TRAILS AT OVERLAND VISION FILING NO. 1

JR RESPONSE: UPDATED TO MATCH COA ITEM #4

TRAILS AT OVERLAND RANCH - SITE PLAN 1

CONTEXT MAP

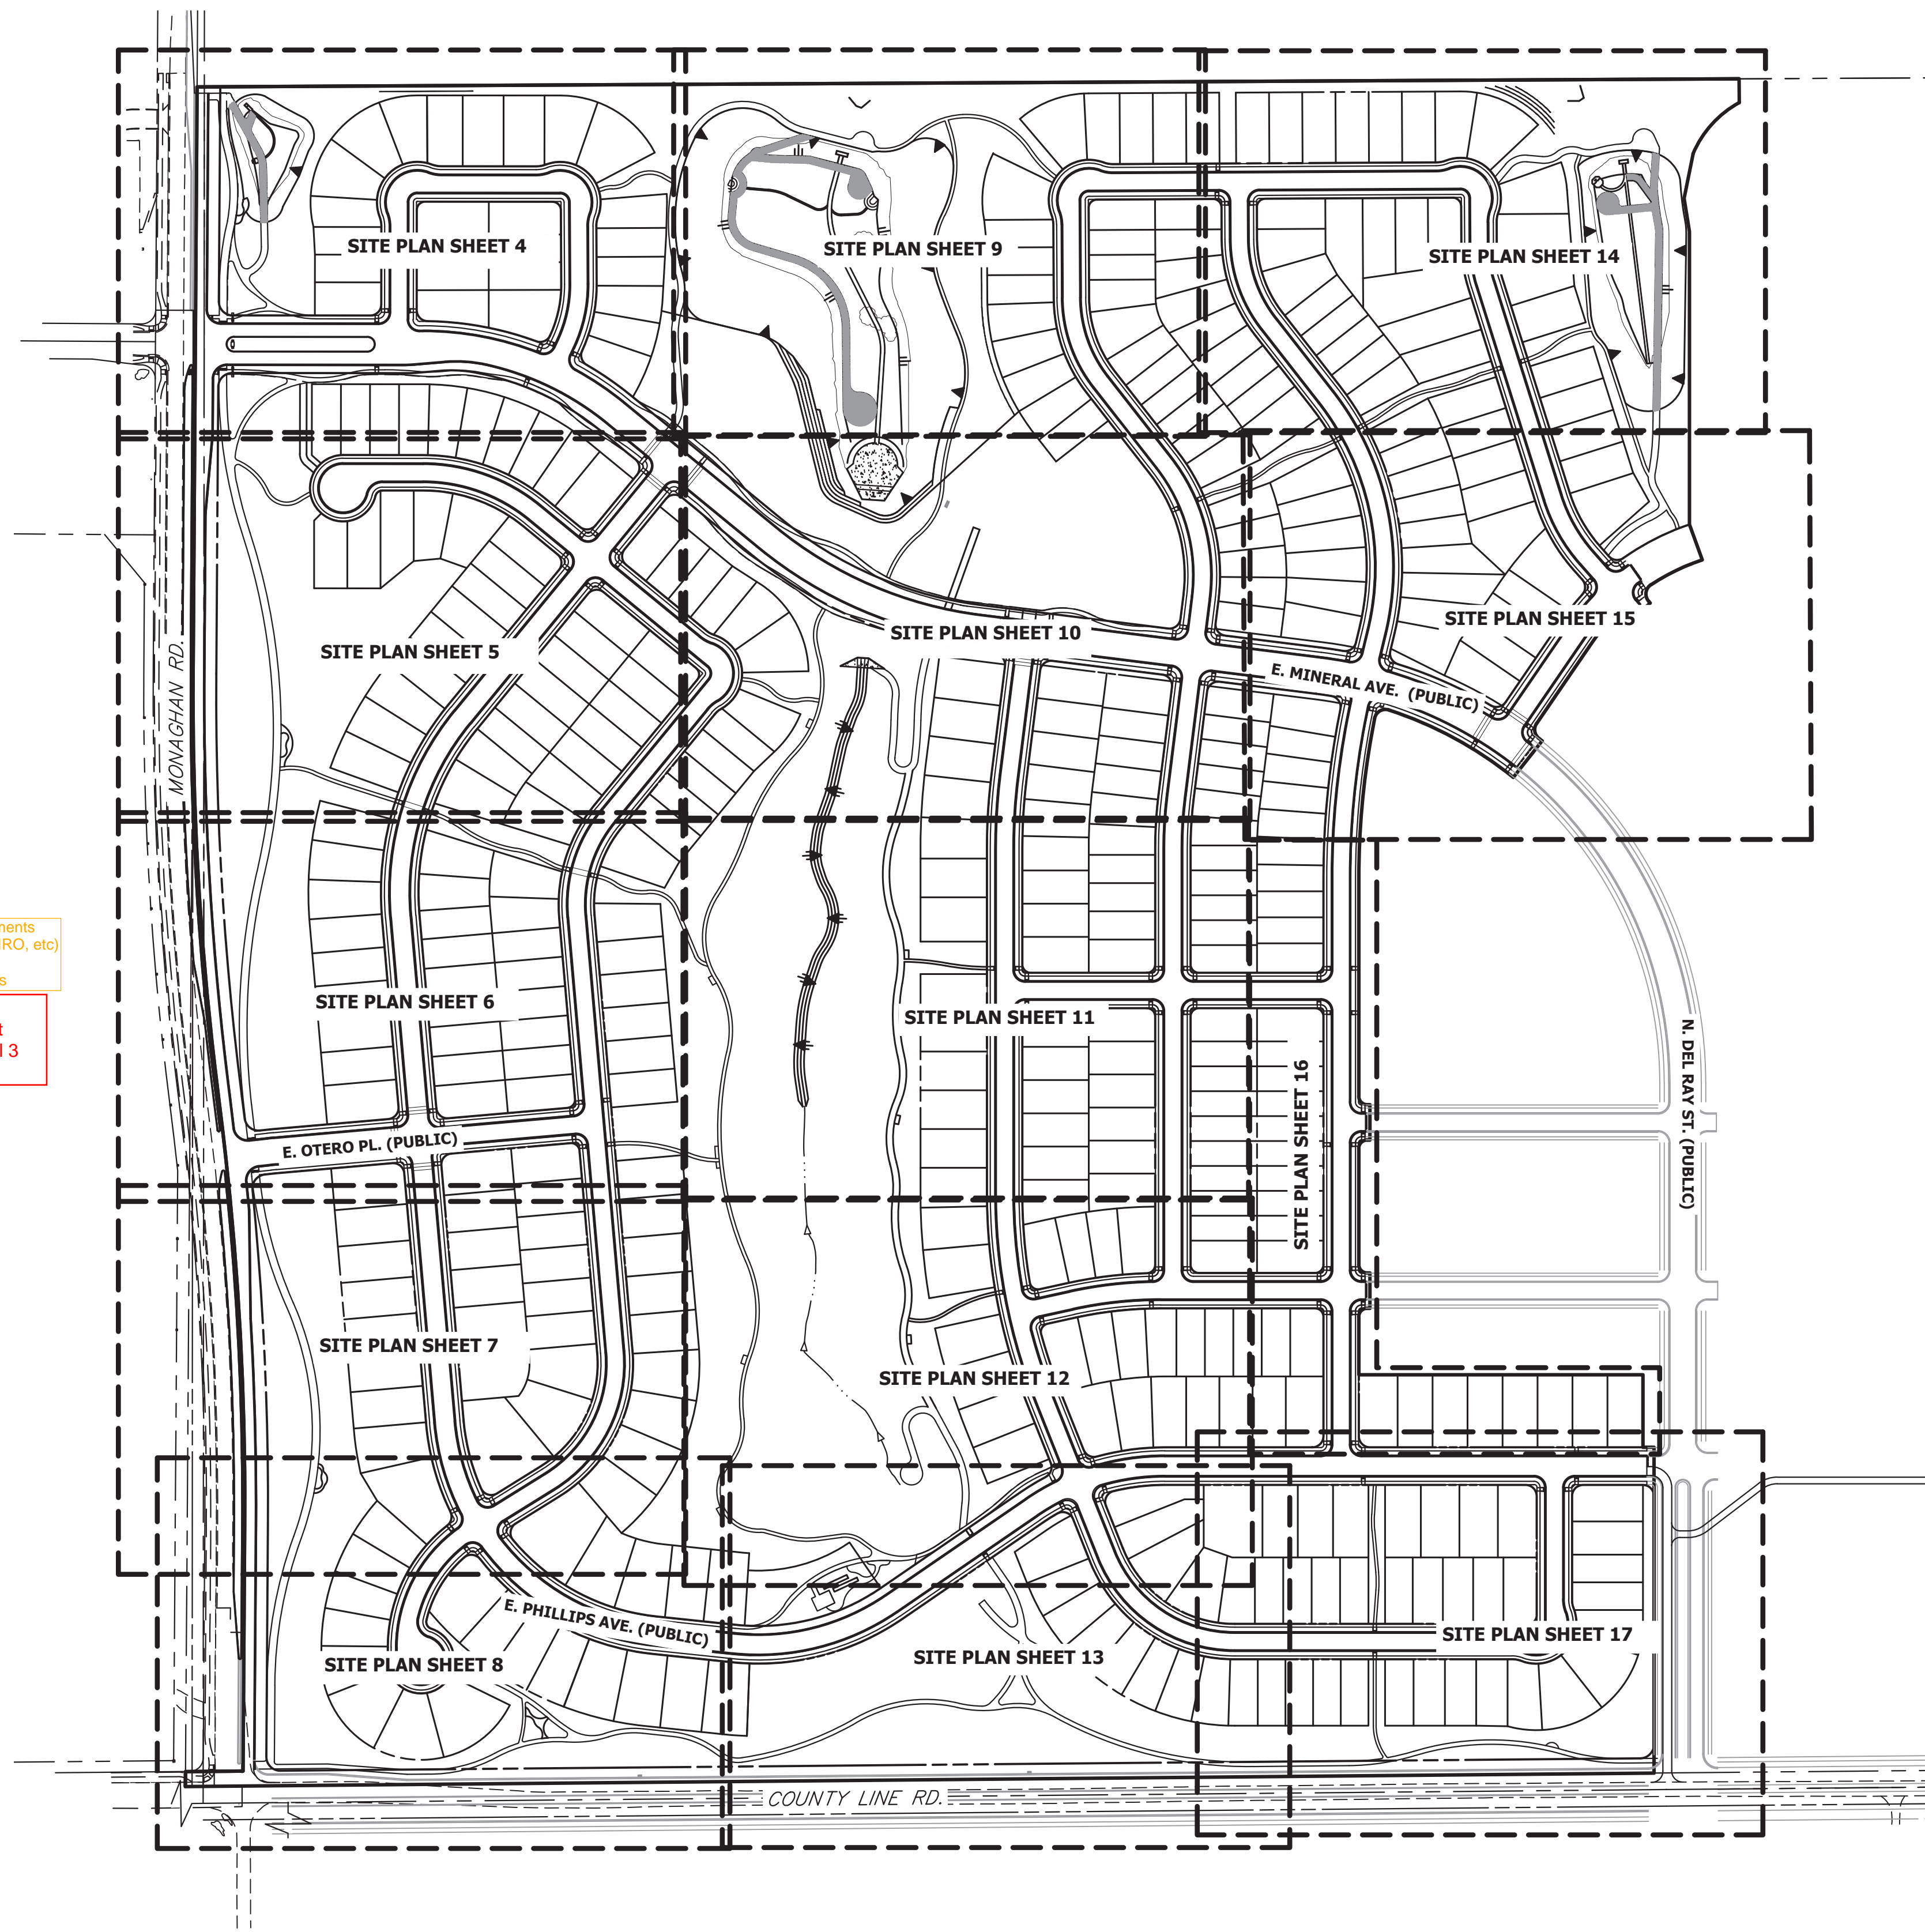
label all access movements
(full movement, 3/4, RIRO, etc)
in conformance to the
MTIS/Master Plan docs

RESPONSE:
access movement
labels added to all 3
site access.

SHEET TITLE:
GRADING & UTILITY PLAN

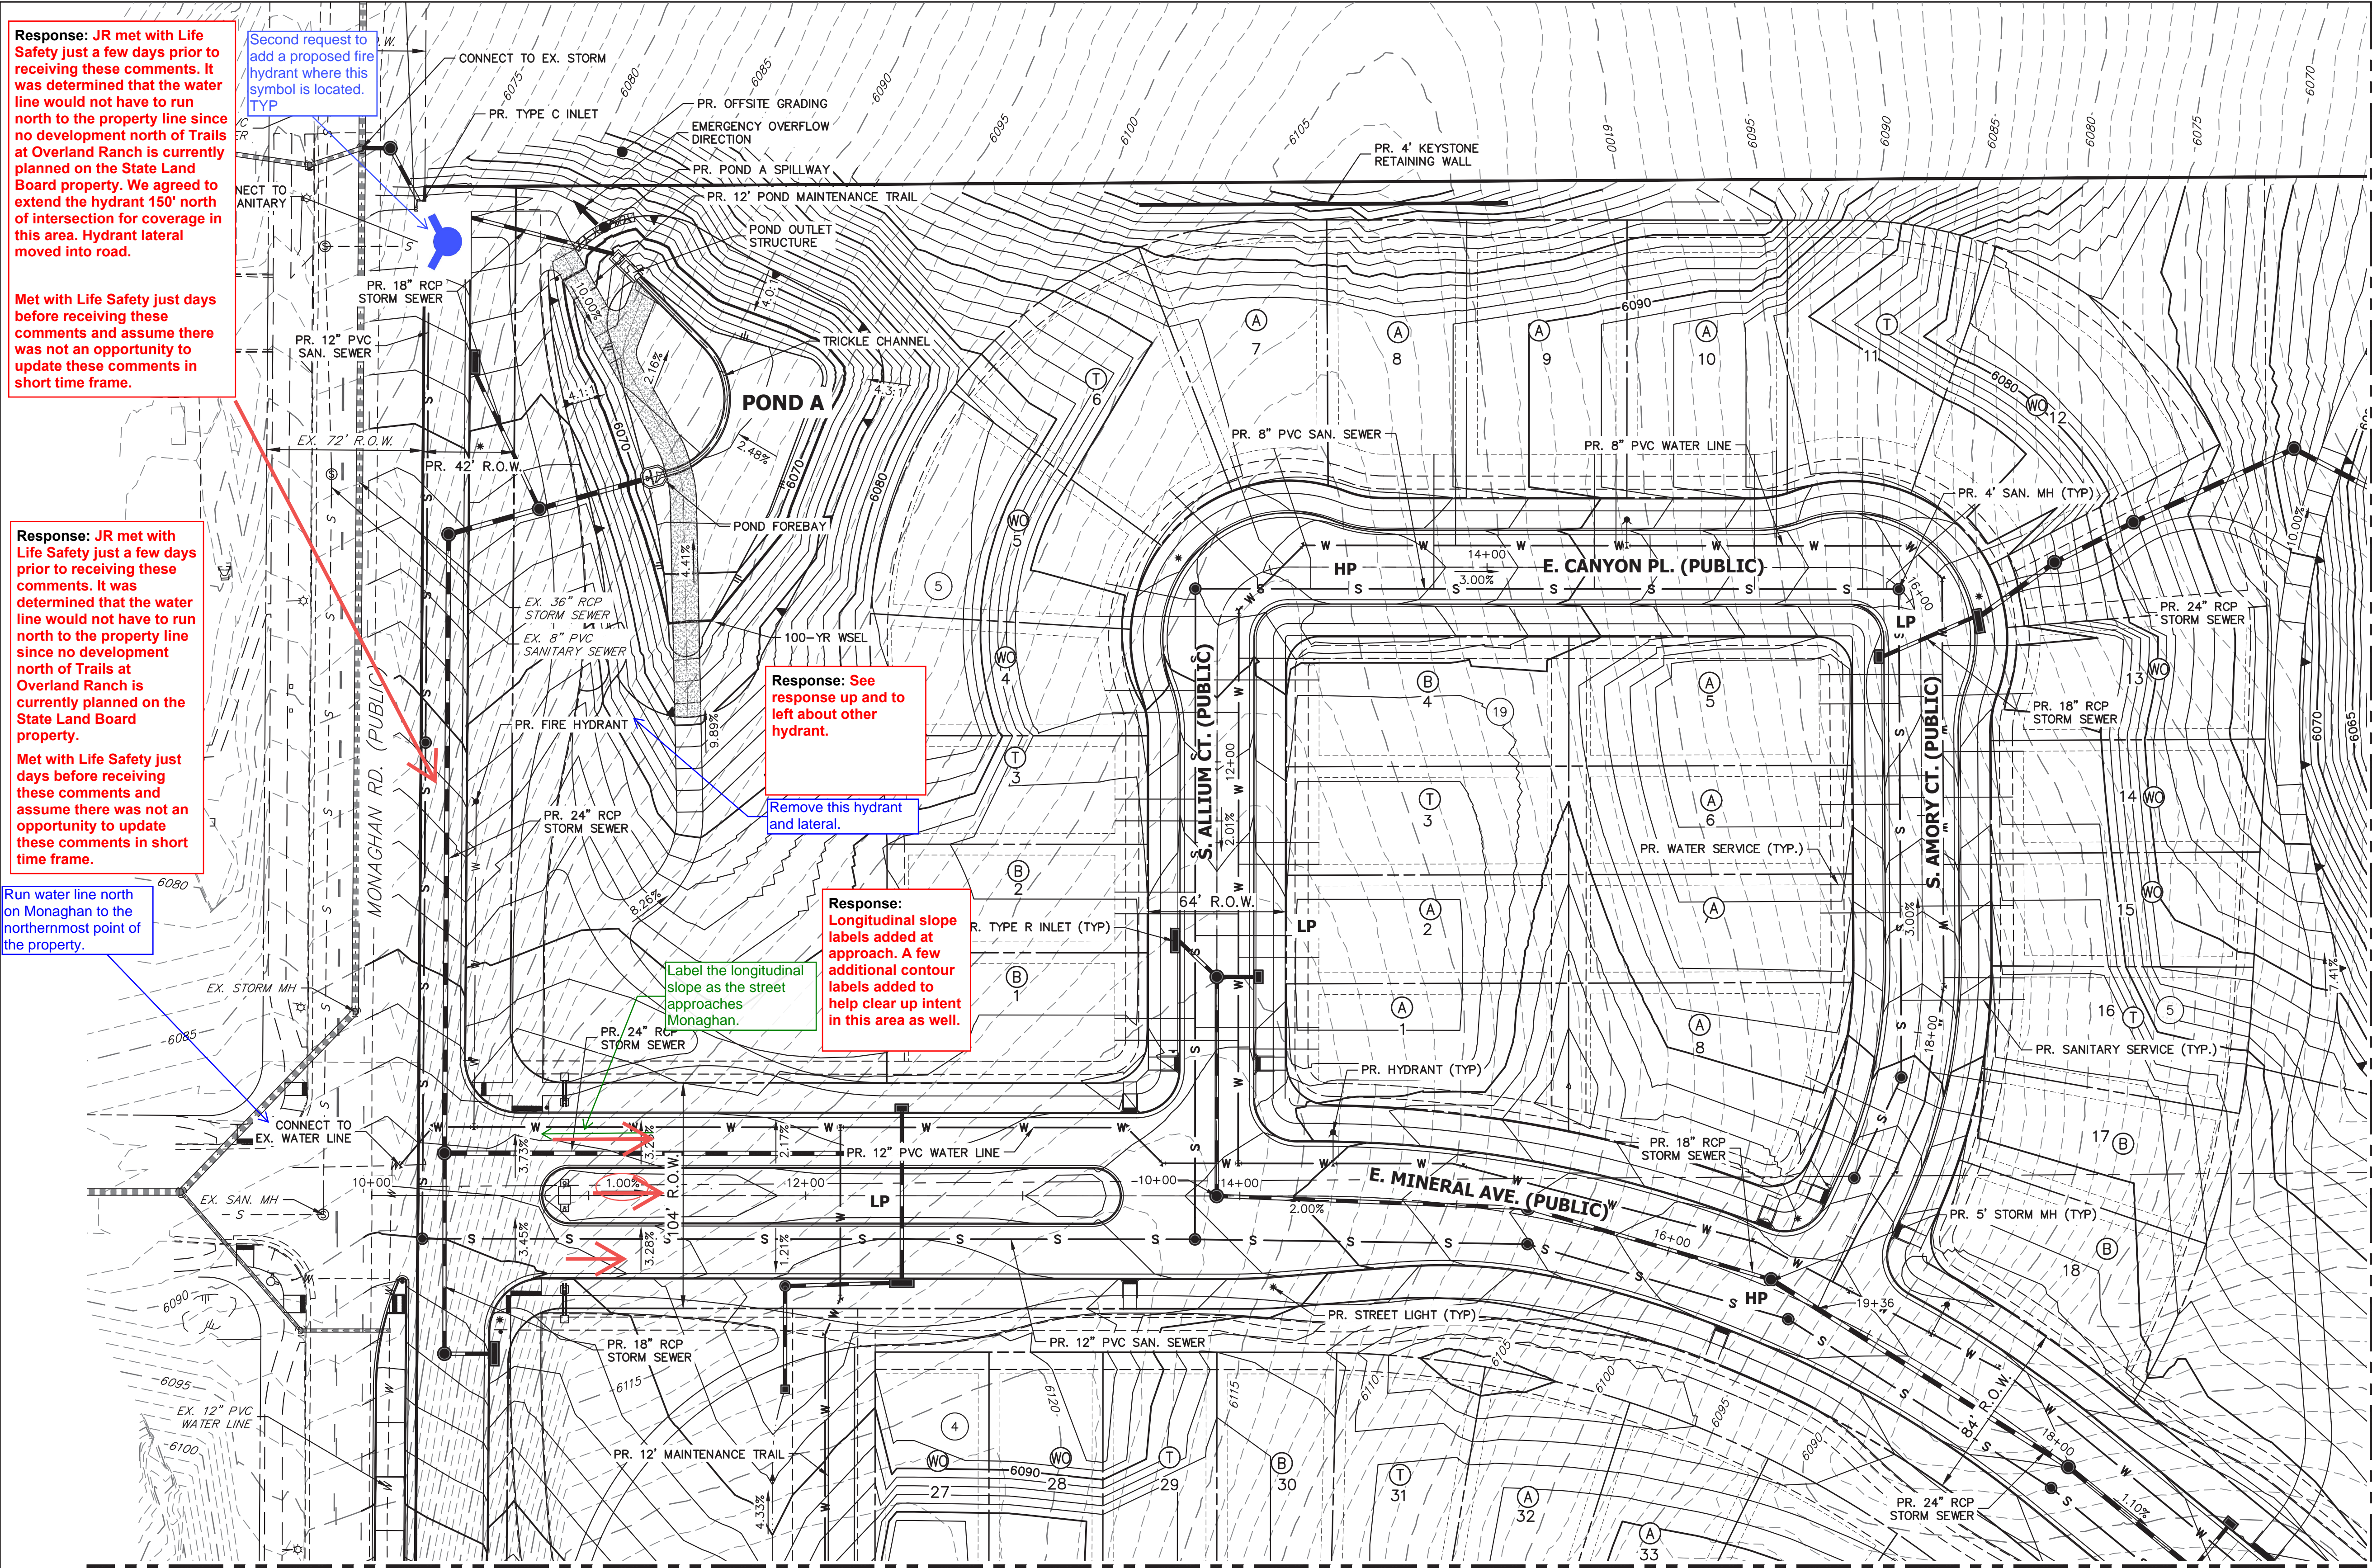
Second request to add a proposed fire hydrant where this symbol is located.

Remove this hydrant and lateral.

Response: JR met with Life Safety just a few days prior to receiving these comments. It was determined that the water line would not have to run north to the property line since no development north of Trails at Overland Ranch is currently planned on the State Land Board property. We agreed to extend the hydrant 150' north of intersection for coverage in this area. Hydrant lateral moved into road.

Response: See response up and to left about other hydrant.
